Submission to DoIR on Recommendations for Well and Borehole Naming

**From the FESWA Data Standards and Best Practices Group
21-Jun-2007**

Summary

Figure 3: Examples of labelling coreholes and deepenings

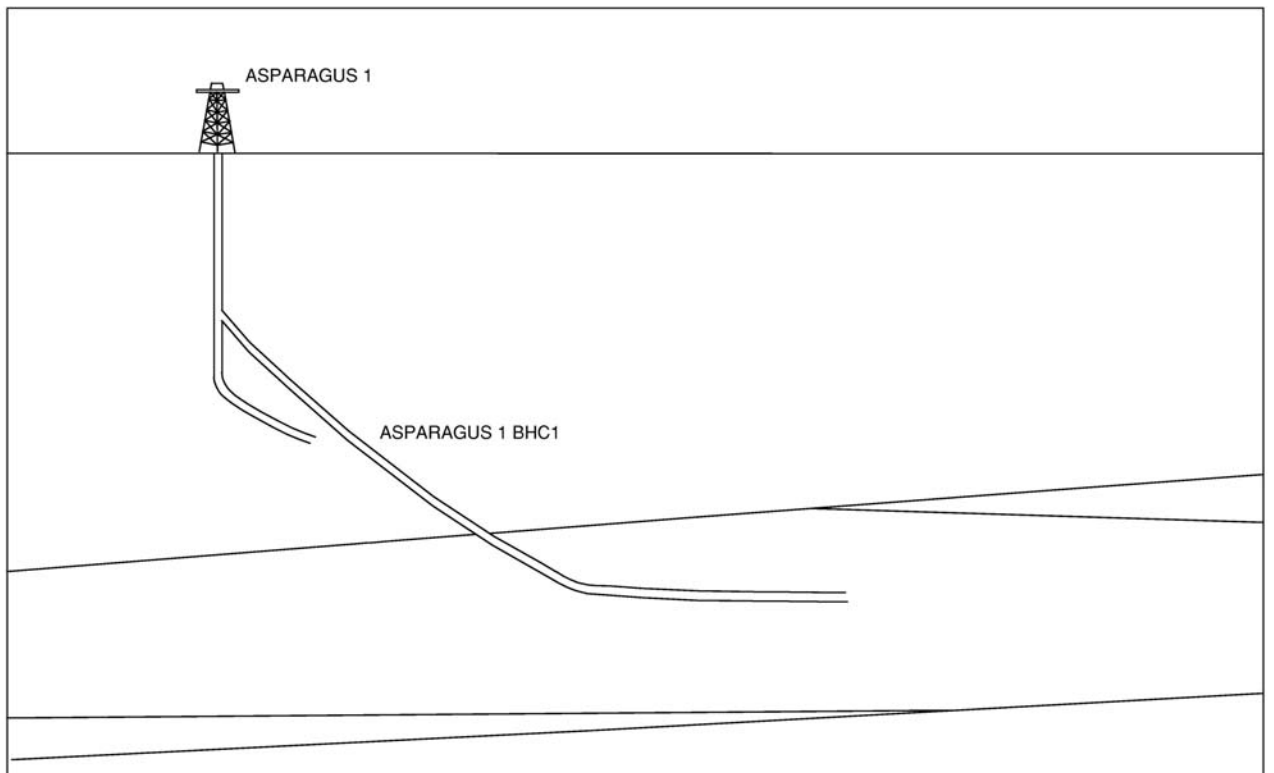
In the DoIR proposal, Type 7 in Table 1, the DoIR propose a “-CH1” suffix for a well that is side-tracked for the purpose of coring. In line with the key FESWA principles, this is a sidetrack specifically undertaken for coring and as such no purpose should be attached to the well name, that is, the suffix should be “-ST1”.

In the case of deepening of a well, Type 13 in Table 1), FESWA suggests that this is a special case of a sidetrack and that the suffix should be "-ST1".
